Private Plan Change Request at 40 Mahi Road, Helensville and a Request for Further Information Pursuant to Clause 23 of the Resource Management Act 1991

Appendix A – Full Expert Responses 09/04/2025

Appendix B – Version 09/04/25

Figure 5: A snip from amended precinct plan (Civix Ltd.) showing amended legend and "Potential Riparian Areas"

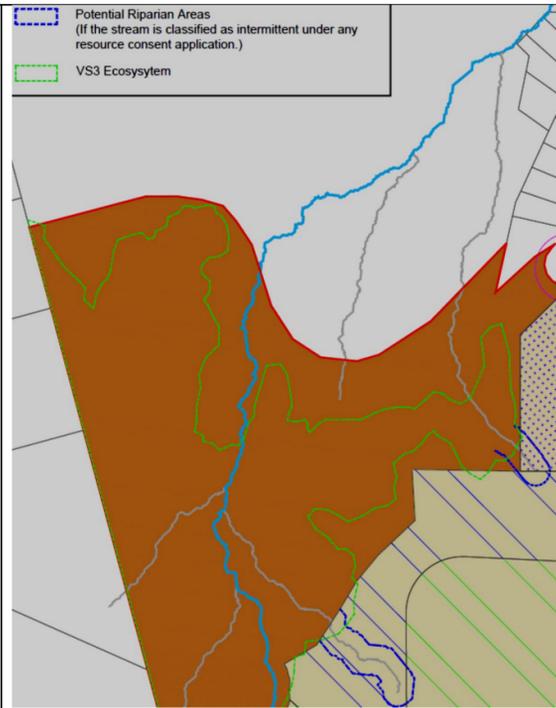
E2	Please provide an updated watercourse map for the site that clearly illustrates the appropriate classification for each stream.	There is some ambiguity regarding the stream classifications. The Ecological Assessment report indicates that “Stream 3” and “Stream 6” are both ephemeral, and therefore would not be subject to riparian margin/yard restrictions. However, the Proposed Precinct Plan prepared by Civix indicates “potential riparian areas” along these streams where they extend into the proposed SHZ. Clarity should be provided regarding the status of these streams. Also, if some gorse has now been removed, areas of stream that were previously inaccessible may now be able to be assessed in more detail.	<p><i>Refer to Section 5.4.1 and Appendix A of the updated Ecology Assessment for a description of all watercourses on site and a map of all watercourses and their classification. I am confident that Stream 6 is ephemeral, and that Stream 3, where it flows through the more ‘open’, proposed Single House Zone (SHZ) areas, is also ephemeral.</i></p> <p><i>Watercourses were classified and delineated (where accessible) on site in general accordance with criteria outlined in the Auckland Unitary Plan (AUP:OP) Chapter J Definitions. Stream 3 and Stream 6, where they flow through proposed Single House Zone (SHZ), were both classified as ephemeral (and not intermittent) due to their small catchment size (1.08 ha for Stream 3 and 1.1 ha for Stream 6), and because they did not contain flowing water and/or natural pools, did not have well-defined channels with the bed and banks easily distinguished, rooted terrestrial vegetation were established across the entire cross-sectional width of the channels, no organic debris was seen on the floodplains, and no evidence of substrate sorting or scour was visible. These streams therefore did not meet at least three of the of the intermittent stream criteria, which are:</i></p> <ul style="list-style-type: none"> <i>• it has natural pools;</i> <i>• it has a well-defined channel, such that the bed and banks can be distinguished;</i> <i>• it contains surface water more than 48 hours after a rain event which results in stream flow;</i> 	Satisfied	Revised map is satisfactory.	N/A

Stream 6

The headwaters of Stream 6 originate in exotic scrub (ES) transitioning into VS3 manuka/ kanuka scrub (Figure 3), where the dense vegetation and steep slopes made it difficult to assess during the site visits. Further north in the proposed CLZ, the stream flows into a wider gully with wetland vegetation visible along its margins, mostly outside the site boundary (as seen in Figure 4).

The Precinct Plan's legend has been amended to "Potential Riparian Areas (if the stream is classified as intermittent under any resource consent application)". See Figure 5 next page.

Figure 6: Indicative riparian planting area (1,300m²) (if required at resource consent stage) showing existing riparian vegetation along part of Stream 1, comprising of exotic scrub and grassland adjacent to kanuka/manuka scrub.

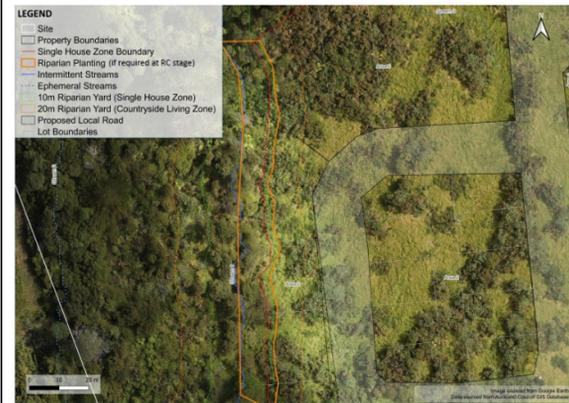
E3 Please provide a map that shows both the updated vegetation type extents and the updated watercourse classifications.

There is some ambiguity regarding the vegetation currently present in the riparian margins of the streams. For example, Photo 10 in the Thomas Consultants report shows Stream 1 flowing through open grassland, but the map appears to indicate that it flows through a mix of mānuka/kānuka scrub and gorse shrubland. The vegetation present in the riparian margins is also relevant as it will influence an assessment of the potential ecological benefits associated with the proposed riparian margin planting.

After careful, detailed analysis of the high-resolution drone imagery, vegetation along Stream 1 was remapped, with a small area of exotic grassland (EG) in the southwestern corner of the site where Stream 1 enters the site. For the most part, Stream 1 flows through VS3 manuka/kanuka scrub which changes to a grassland/exotic scrub mix further north (refer to updated vegetation map in Appendix A of the updated ecology assessment attached).

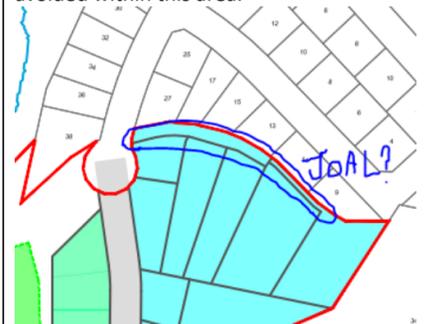
RE3	It looks as though there are only proposed public roads, i.e. no ROW's. on the proposed concept masterplan there is a strip at the rear of two blocks of lots. As the sites already have road frontage what are these?	Demonstration that compliant grades can be achieved both for roads and verify if there are any Privateways.	<p>As highlighted above this is a concept masterplan to test a typical earthworks design which suits the existing topography. The concept masterplan identifies these as private accessways. Please refer to drawing 46000 showing spot gradients which indicate that compliant gradients are achievable. These private</p>	Satisfied	Acceptance of responses at this stage is conditional. Auckland transport needs to be consulted at resource consent stage to provide assessment on design gradients, visibility gradients and stormwater control.	N/A

accessways would typically follow the gradient of the adjacent public roads			
#	Specific Request	Reasons for request	Applicant response			
Transportation – LANDEV Refer to the updated Traffic Assessment Report Revision D for detail.						
T1	Please update the Transport Assessment to provide details of the total trip generation of the site (including person trips), details of the accessibility of the site to the wider network / amenities for active modes and assessment against relevant national and regional plans and policies.	The Transport Assessment Report has been prepared as though it is supporting a resource or sub-division consent and not a Plan Change. An Integrated Transport Assessment would typically be prepared to assess the transport effects of the proposed re-zoning of the land. Whilst it is acknowledged that the scale of the development enabled by the rezoning may be relatively limited, the transport assessment should include details of the total trip generation of the site (not just vehicle trips), details of the accessibility of the site to the wider transport network and amenities for active modes and public transport and should include an assessment of the plan change against relevant plans and policies. This information is required to understand the traffic and transport effects of the proposed change to the zoning of the land.	The responses to this are within the updated traffic assessment in Section 6.0 of the Traffic Assessment Reference 24240 Rev as attached. Further assessment of relevant objectives and policies is included in Section 13.0 of the Traffic Assessment.	Partially Satisfied	Please provide details of the forecast person trips.
